FINAL SAFETY EVALUATION REPORT
TRANSNUCLEAR, INC.
STANDARDIZED NUHOMS® HORIZONTAL MODULAR STORAGE
SYSTEM FOR IRRADIATED NUCLEAR FUEL
DOCKET No. 72-1004
AMENDMENT NO. 10

Figure 4.4 Effective Conductivity Regions in SAR Model of OS200 Neutron Shield (adapted from Figure 4-2 of NUHOMS[®]-HD Amendment 1 SAR)

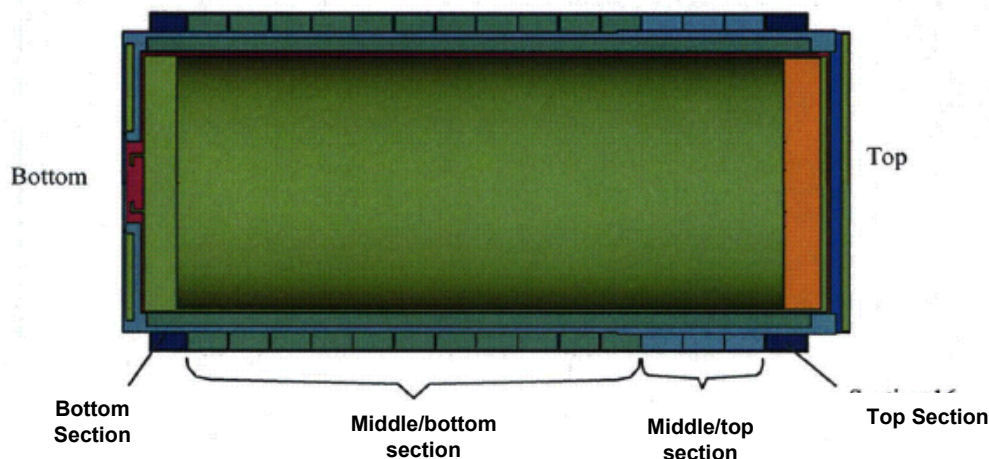
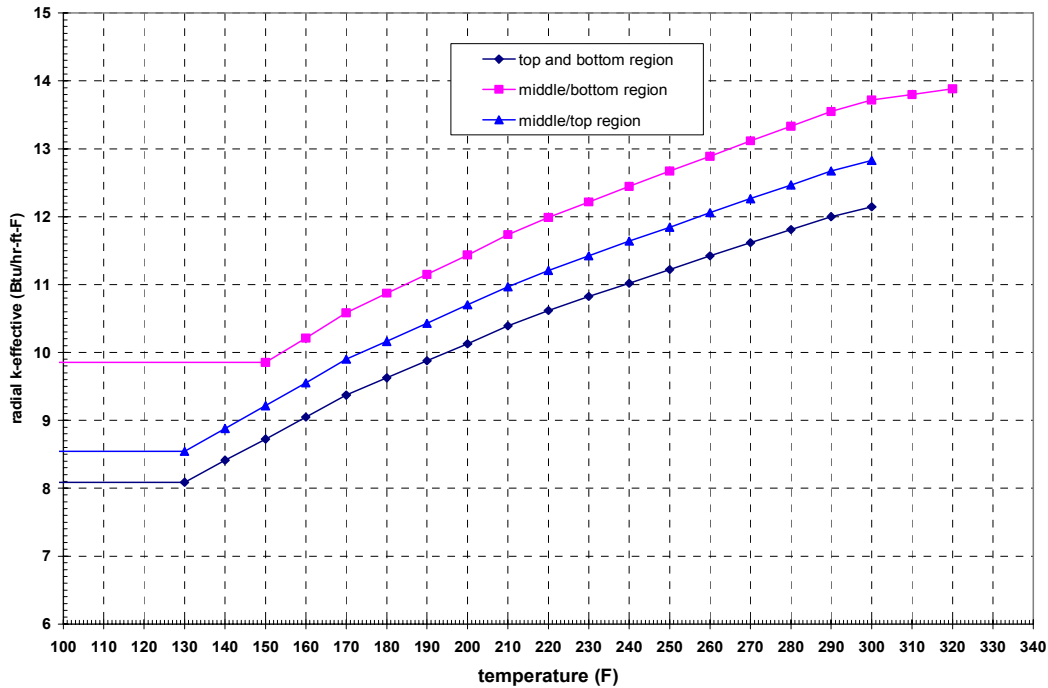
The k-effective model used in the analyses in the SAR formulates the effective conductivity as a function of temperature, and for application to the horizontal transfer cask, defines slightly different relationships for different axial regions of the neutron shield annulus. Figure 4.4 illustrates the location of each of these regions along the neutron shield annulus, and Figure 4.5 shows the k_{eff} values¹ defined in each region as a function of temperature. These two figures illustrate particular features of the SAR k-effective model for the neutron shield that could affect the accuracy and conservatism of transfer cask temperatures, and therefore the DSC temperatures, including the peak clad temperature. Specific concerns include:

- the assumption of radially uniform heat transfer rates around the full circumference of each segment of the neutron shield tank annulus
- the assumption that the effect of the stagnant regions at the top and bottom of the annulus (at the line of geometric symmetry) can be ignored

Figure 4.6 Effective Conductivity for Water-filled Neutron Shield (OS197 TC) from SAR

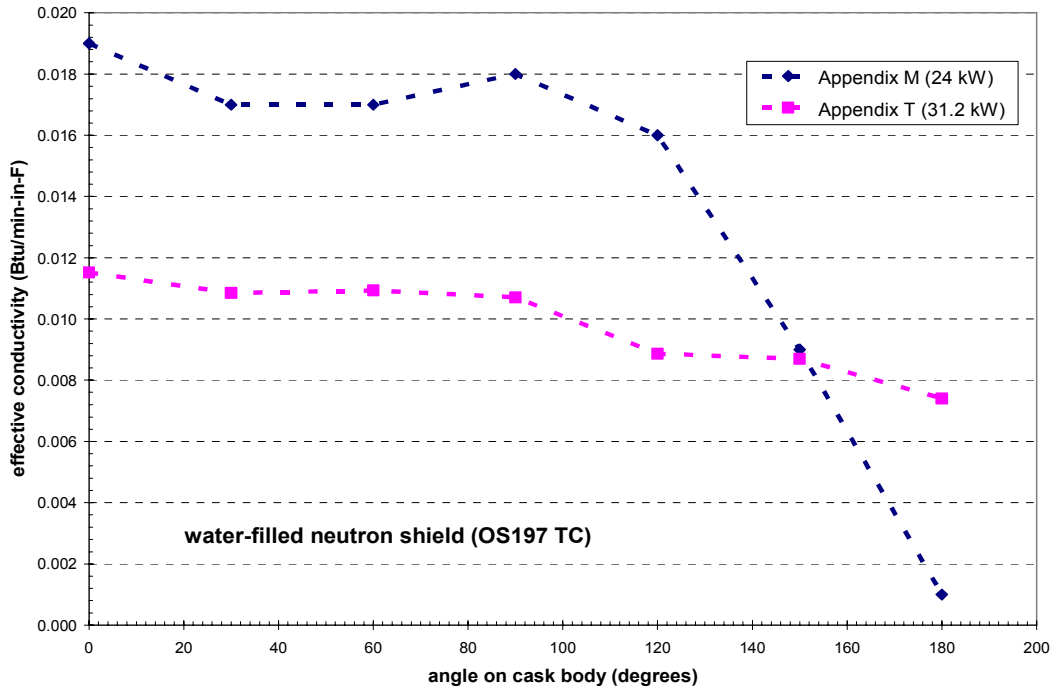
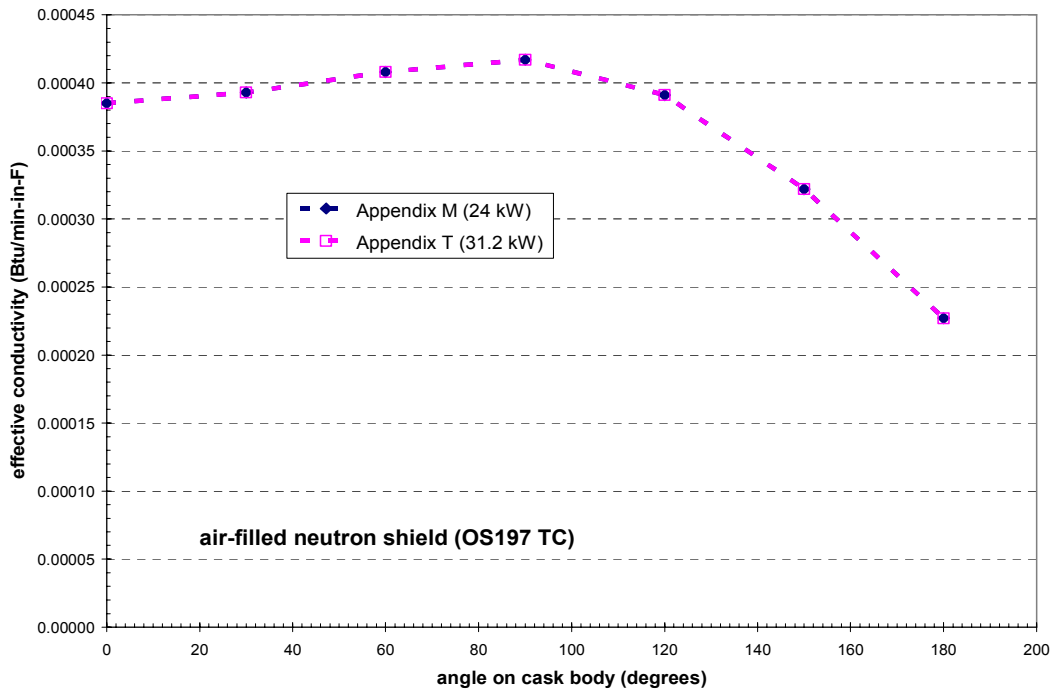
- Figure 4.6 compares the water-filled neutron shield effective conductivity from Appendix M to the values reported in Appendix T (Section T.4.2, item 17). Figure 4.7 presents a similar comparison for the air-filled neutron shield effective conductivity from the two sources. Figure 4.6 shows that the effective conductivity values reported in Appendix T of the SAR, for the water-filled neutron shield, are clearly not the same as the values reported in Appendix M. Figure 4.7, however, shows that the values are exactly the same for the air-filled neutron shield.

The applicant should justify this assertion, by calculating the appropriate effective conductivity values for the applications in Appendix T, and comparing the results obtained to the values reported in Appendix M.

Figure 4.12 Direct Comparison of DSC shell outer temperature results from StarCD model and ANSYS model³ from the SAR.

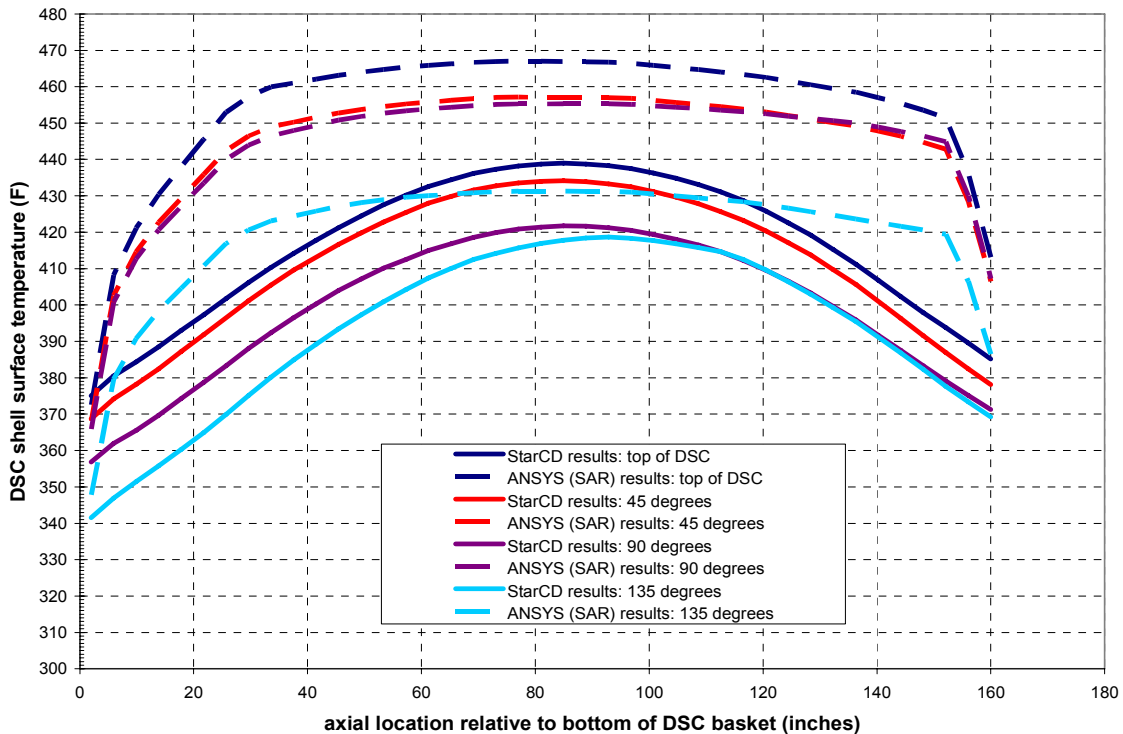
These results indicate that the modeling approach used in the SAR is conservative, in that it tends to over-estimate the DSC shell temperatures, and predicts a greater area of the DSC

³ Note that the SAR temperatures in Figure 4.12 are from Rev. 0 of the SAR, before correcting the dead zone angle on the DSC shell from 4.2° to 18.9°. The overall effect of the correction is to increase the predicted peak DSC shell temperature by 18-25 °F. Because the one-dimensional stack effect model for air flow and air temperature boundary conditions is unaffected by this correction (see Revision 3 of the SAR), the general shape of the temperature profiles would remain unchanged.

Figure 4.14. Representative Results of CFD Modeling of OS200 Neutron Shield Segment Compared to SAR k-effective Model of Neutron Shield

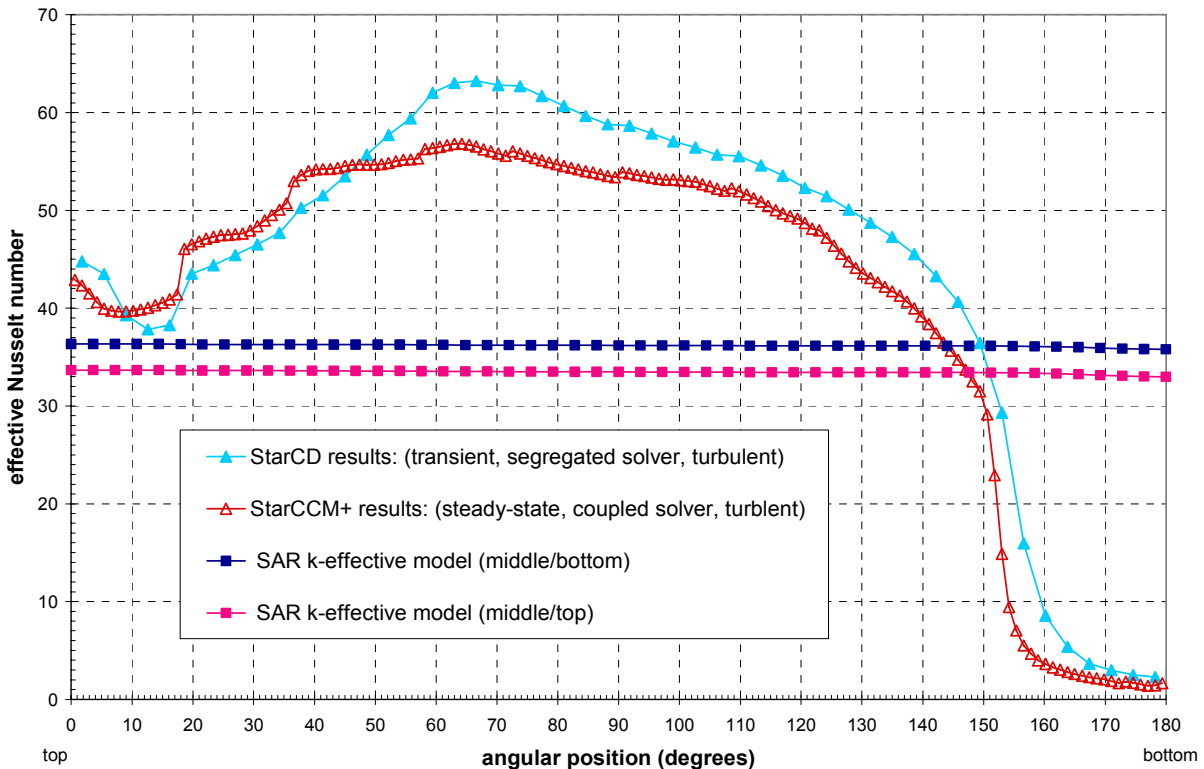
The Nusselt number values should not be taken as a definitive description of the heat transfer behavior in the OS200 neutron shield. However, these results can be taken as a reasonably realistic picture of the distribution of the heat transfer rate around the circumference of the neutron shield annulus. This provides a basis for evaluating the k-effective model for the neutron shield, as presented in the SAR.

The CFD results show that although the k-effective model for the neutron shield may be conservative over most of the circumference of the horizontal annulus, it is clearly not conservative over the bottom portion of the tank, spanning a region of approximately 60°, centered on the vertical axis through the horizontal tank. This constitutes approximately one-sixth of the circumference of the tank, and as such, could significantly erode the conservatism for the neutron shield k-effective model.

Figure 4.15. Variation of Assumed Neutron Shield Effective Nusselt Number for OS200 TC

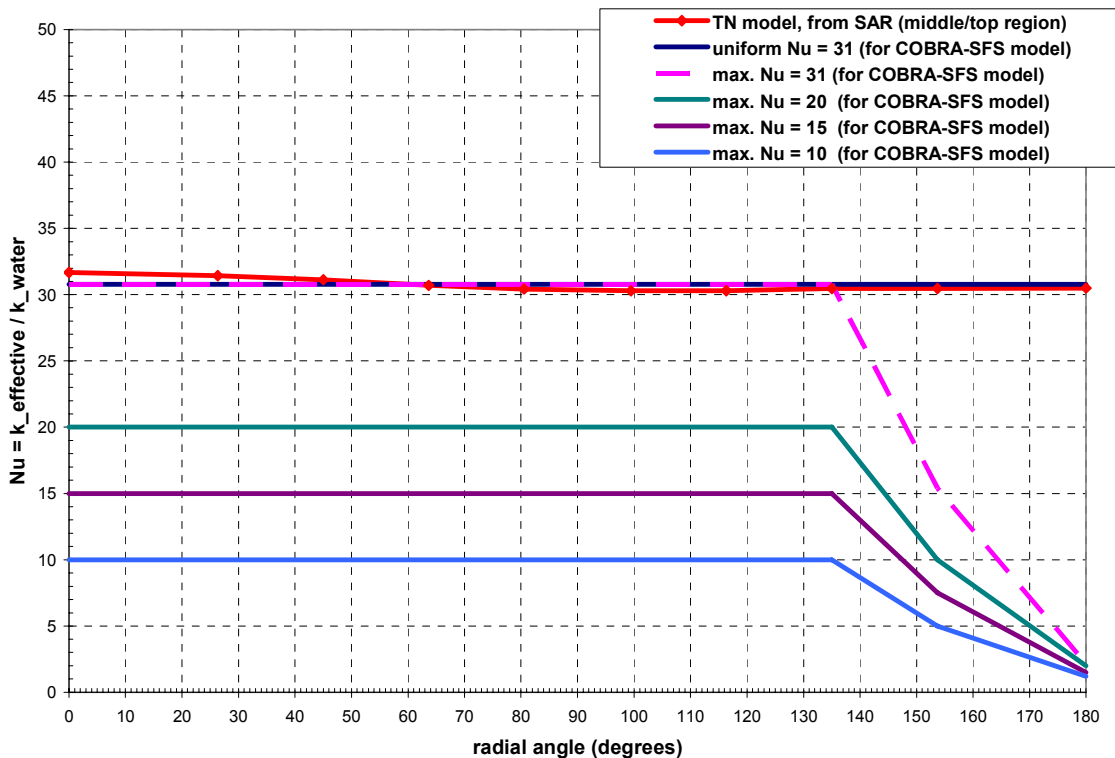
To evaluate the effect of a radially non-uniform Nusselt number on the peak temperatures obtained in the DSC, additional confirmatory calculations were performed with a detailed COBRA-SFS model of the DSC within the transfer cask. This model included the representation of the DSC that was used in the evaluations described above for confirmatory calculations in the storage module, but in addition included detailed representation of the transfer cask, including the non-uniform air gap between the DSC outer shell and the TC inner liner. The neutron shield tank was modeled in a manner similar to that used in the detailed SAR model, with an effective thermal conductivity defined for the neutron shield. Calculations were performed with uniform and radially varying effective thermal conductivity values, as illustrated in Figure 4.15. These calculations were performed for the limiting configuration⁵ without forced air cooling, which is the DSC with Type 1 basket, HLZC #2, 31.2 kW.

The results of these calculations are shown in Table 4.24, compared to the corresponding limiting condition results from the SAR, and the Regulatory limit on peak cladding temperature for transfer conditions. For a Nusselt number corresponding to the SAR model (i.e., uniform Nu = 31), the COBRA-SFS results predict a peak clad temperature of 733°F. This is consistent with the bounding value of < 737°F reported in the SAR. For the case where this nominal Nu = 31 is assumed to decrease to a value of Nu = 2 in the bottom region of the neutron shield annulus, the COBRA-SFS calculation predicts a slightly higher peak clad temperature of 738°F. Further
